工程指示 / 要求簡箋 ENGINEER INSTRUCTIONS(E.I.)

Project Proposed Residential Development at TKOTL 70RP, Phase 11, Lohas Park, Tseung Kwan O, New Territories
 Works Main Contract
 Contract No. J3931
 Ref. No. P19084NT/MS/MD/591 (Rev.0)
 GECCL Ref. J3931/304/D03629
 Date 4 Apr 2022
 To / Attn RLP / Mr. Kenneth Wong / Ms. Florence Cheung
 Subject **Material Submission – Midi – Submission of Color Sample for Dowsil 791 (Tailor - Made Silver Champagne) & (Grey) (MS024)**

Re: Design, Supply and Installation of Curtain Wall, Glass Wall, Aluminium Window, Aluminium Cladding, Aluminium Louvres and Glass Balustrade Nominated Sub-Contract at T.K.O.T.L. 70 RP, Phase 11, LOHAS Park, Tseung Kwan O, N.T. Submission of Color Sample for Dowsil 791 (Tailor - Made Silver Champagne) & (Grey) (MS024)

Sealant colour

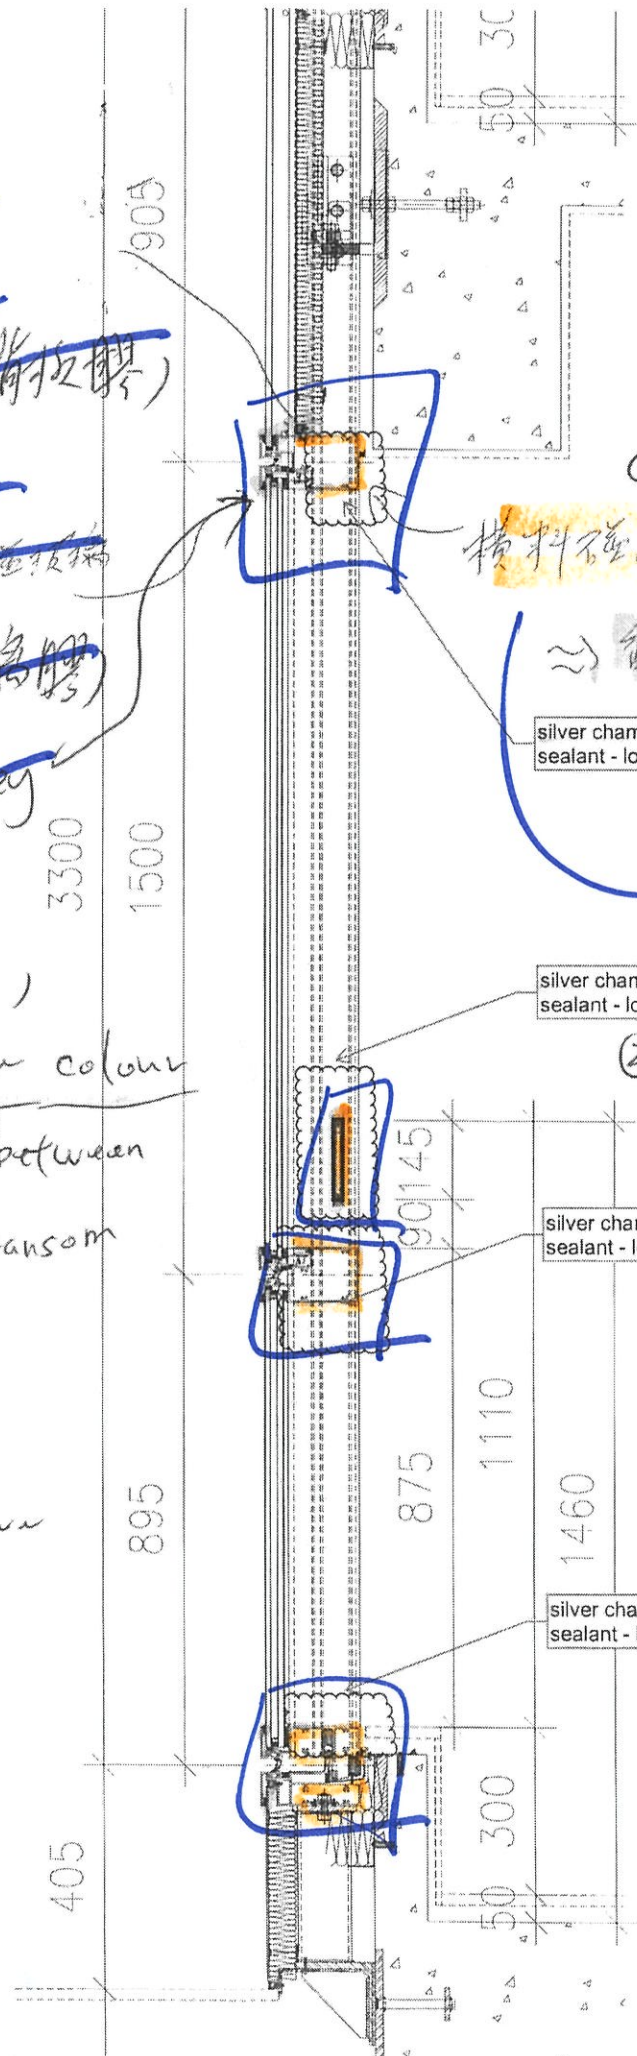
香檳色 silver champagne sealant - location 1

Standard colour confirmed to be grey. Please coordinate with Polyfair for confirmation.

① Interface between mullion and transom (inside.)

② protective Barrier.

silver champagne sealant - location 2

silver champagne sealant - location 3

silver champagne sealant - location 4

Date 22 April 2022
 Comments 1/ Please refer to comments marked on the attached pages
 2/ Item no. 1 - tailor-made silver champagne weather sealant (approval status - B)
 3/ Item no. 2 - standard colour grey shall be changed to standard colour DARK GREY (approval status - c)

change to Dark Grey as per latest instruction from Sino
